**Response to the request for review on the CDM project activity
“Waste Gas based Captive Power Plant in Liangang Group”
with the registration number 1228**

Attention: Mr. Hans Jurgen Stehr, Chairman
CDM Executive Board to Kyoto Protocol

November 10, 2007

Figure 1. Spatial extent of the Waste Gas based Captive Power Plant in Liangang Group

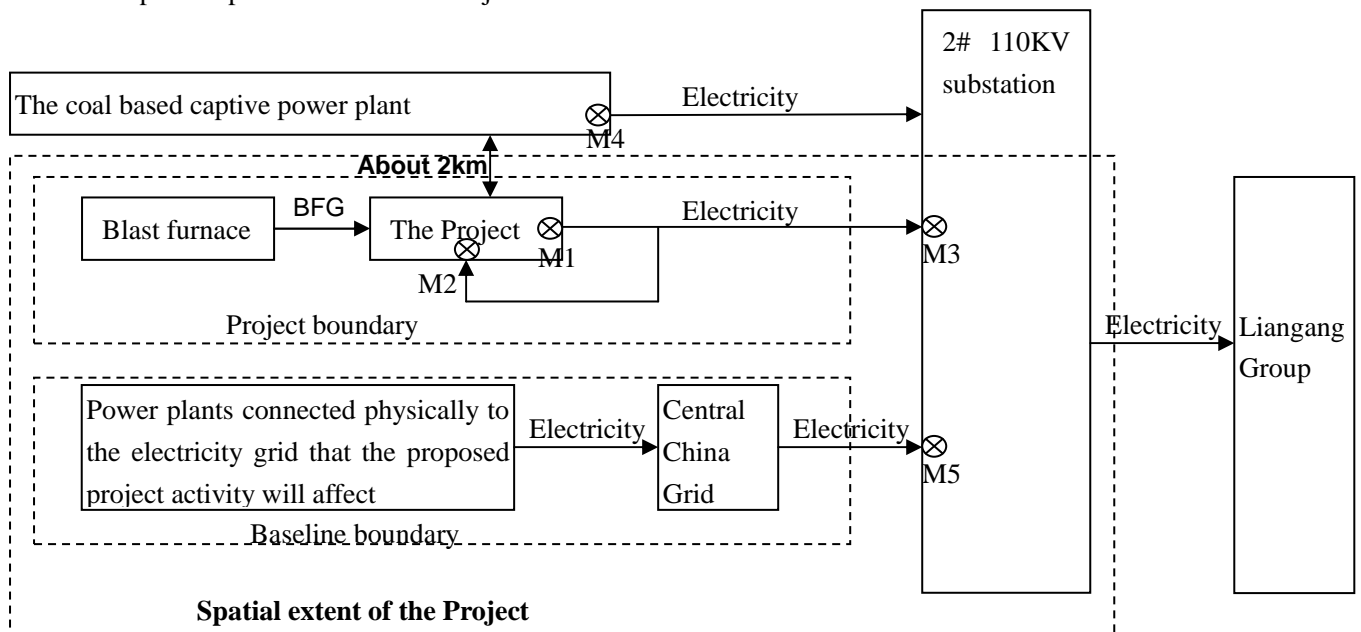
Further clarification is requested as to the exact description of the project activity, the baseline, and the project boundary. A diagram should also be provided.

(3) The Project Boundary:

The baseline of the Project is identified as “blast furnace gas was flared and electricity was supplied from the grid”. To determine the spatial extent of “the power plants connected physically to the electricity grid that the proposed project activity will affect”, definition in the consolidated baseline methodology ACM0002 is applied as per the consolidated methodology ACM0004, and the spatial extent of power system is determined to be the Central China Grid.

Therefore, the spatial extent of the Project comprises the captive power generation equipment of the Project (i.e. the CCPP captive power plant) and the power plants connected physically to the electricity grid that the proposed project activity will affect (i.e. the power plants connected physically to the Central China Grid).

(4) The diagram of the spatial extent of the Project

To make a clear understanding, a diagram below provides the electricity sources of Liangang Group. The spatial extent of the Project is defined with dashed line.

Figure 2. Layout of the Project and the coal fired captive power plant

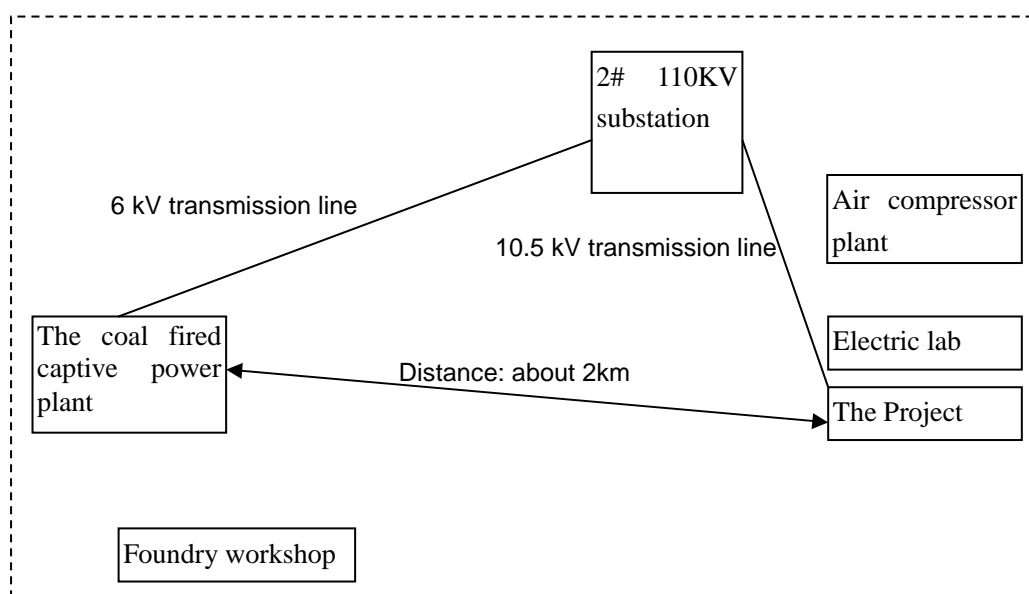
Further clarification is required to demonstrate that the monitoring plan, e.g. the metering of the electricity from the coal based captive power plant and the waste gas/heat will ensure that only emission reductions from the waste gas/heat will be claimed.

Figure 2 demonstrate the distance between the coal fired captive power plant and the Project. It is drawn based on the layout chart provided by Liangang Group⁷.

The distance between the Project and the coal fired captive power plant is about 2 km. Moreover, there is not any physical electric line between the Project and the coal fired captive power plant.

Since electricity generation of the existing captive power plant will not be affected by the Project, metering the electricity from the coal fired captive power plant is not necessary. As shown in the

diagram, metering of the electricity generation and supply of the Waste Gas Based Captive Power Plant in Liangang Group is implemented separately from the coal fired captive power plant. Therefore, only emission reductions from the waste gas will be claimed for the Project.
